LICENSEE: Arizona Public Service Company
FACILITY: Palo Verde, Units 1, 2 and 3
SUBJECT: SUMMARY OF MEETING ON MASONRY WALLS

PALO VERDE MASONRY WALLS
MEETING ATTENDEES
(August 28, 1986)

PRESENTATION ON MASONRY WALLS
FOR THE
PALO VERDE NUCLEAR GENERATING STATION
UNITS 1, 2 AND 3

MODULUS OF RUPTURE FROM WALL TESTS

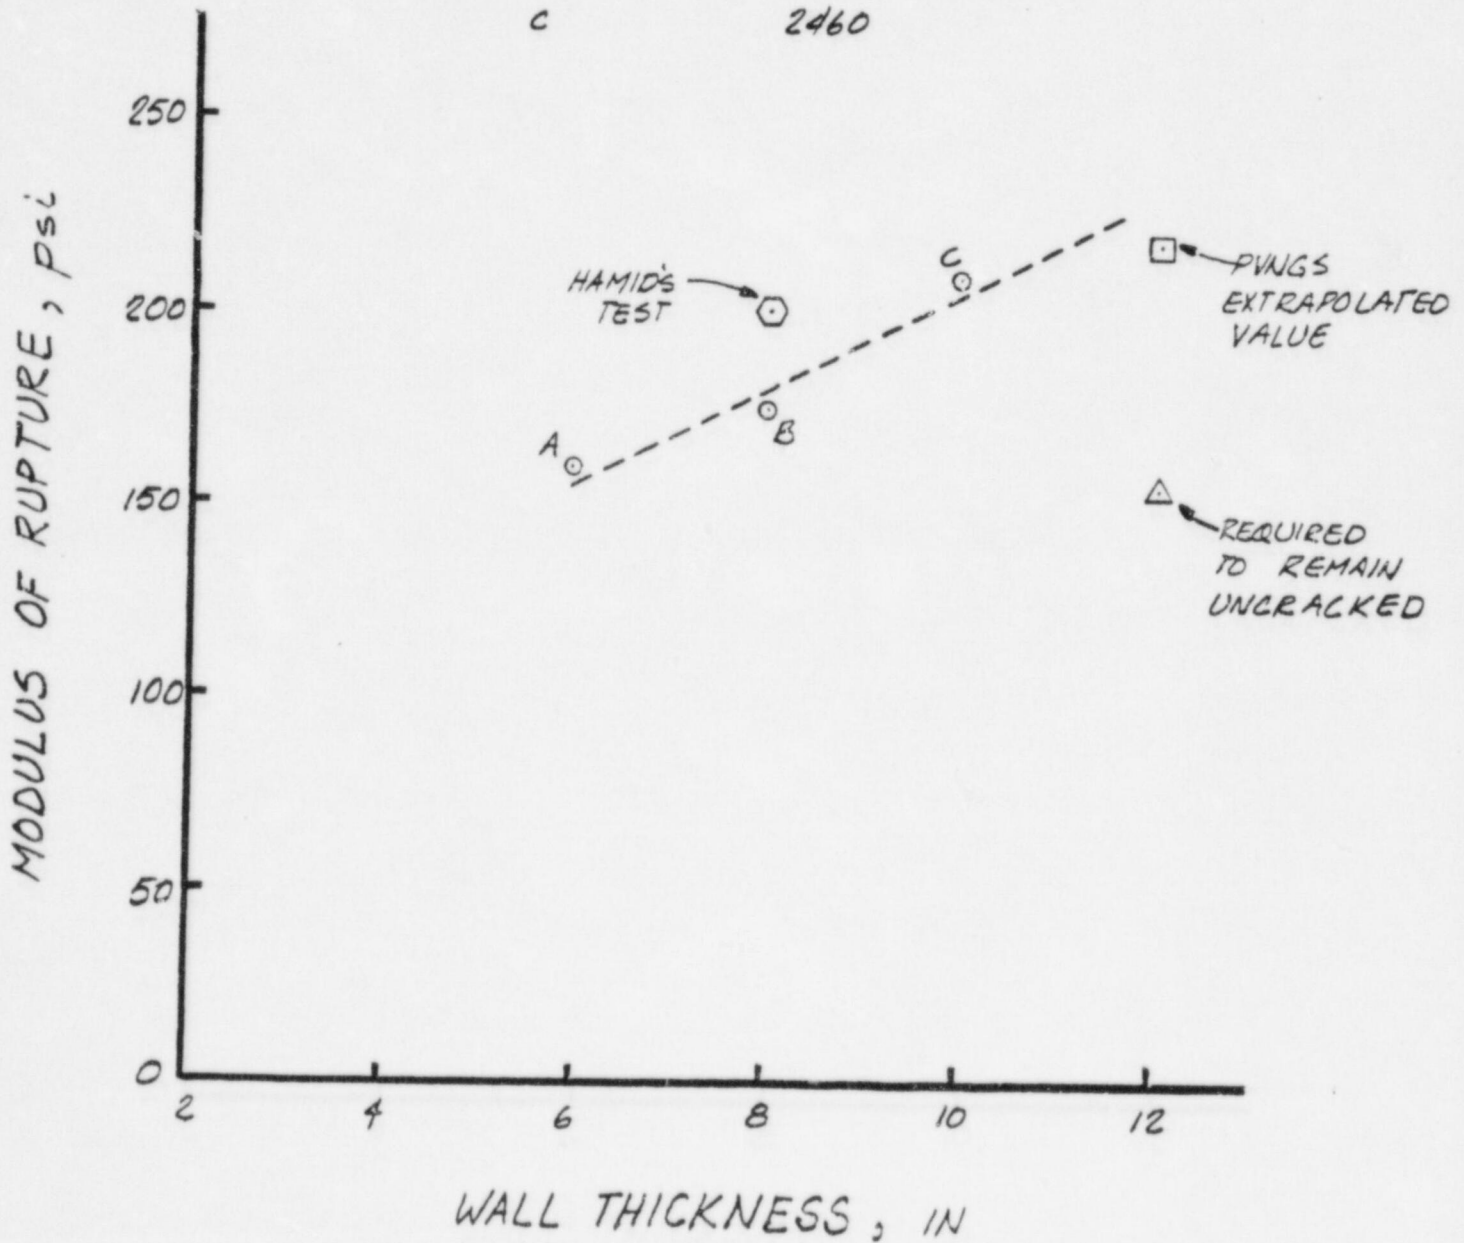
-TEST RESULTS SUPPORT $f_{rm} > 2.5 \sqrt{f'_m}$

- A. HAMID'S PAPER: 203 PSI
- ATKINSON, NOLAND & ASSOCIATES' REPORT: 219 PSI
FOR $f'_m = 2000$ PSI

COMPARISON OF PUBLISHED
AND ENVELOPED WALL SPECIFIC SPECTRA 7% DAMPING

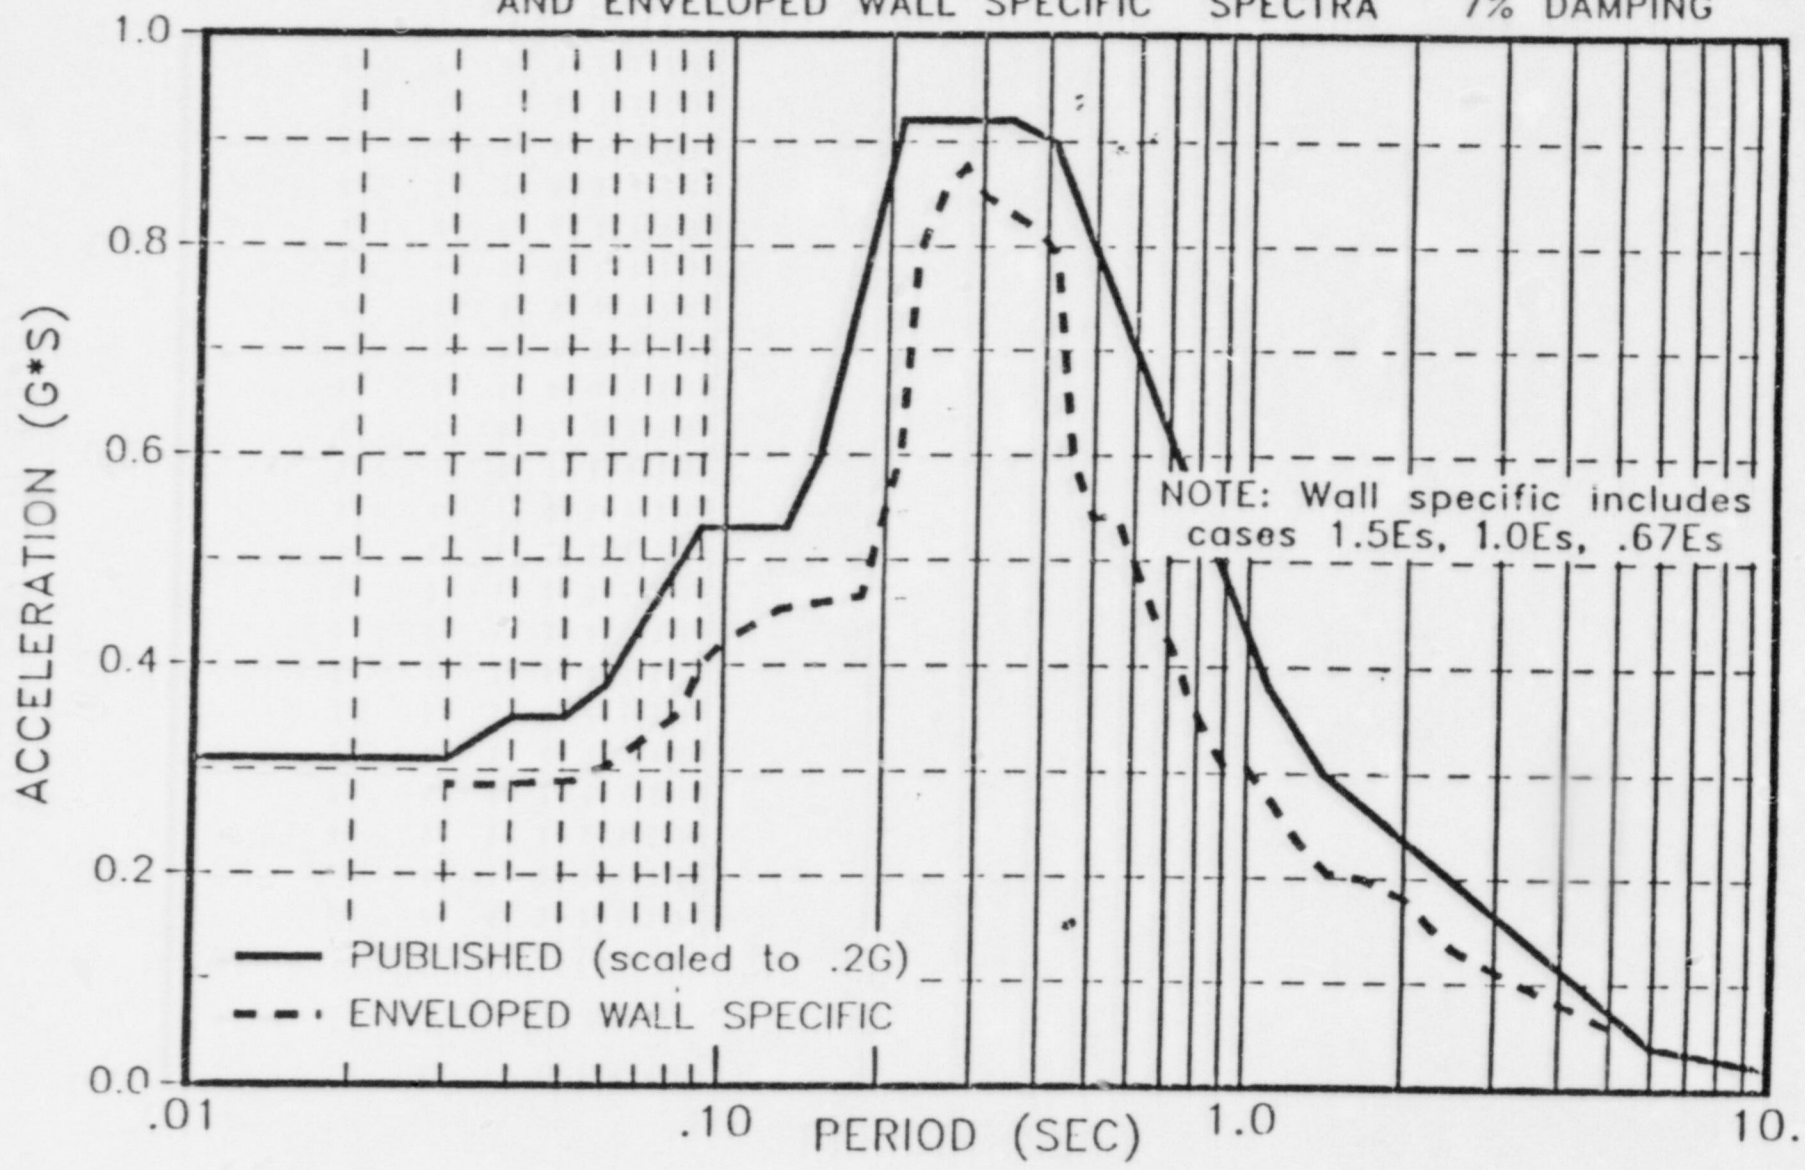
- MARGIN IN STIFFNESS IS 65% (F=6.8 VERSUS 5.3)
- MARGIN BETWEEN M_a AND M_{cr} TO ACCOUNT FOR ..
UNCERTAINTIES
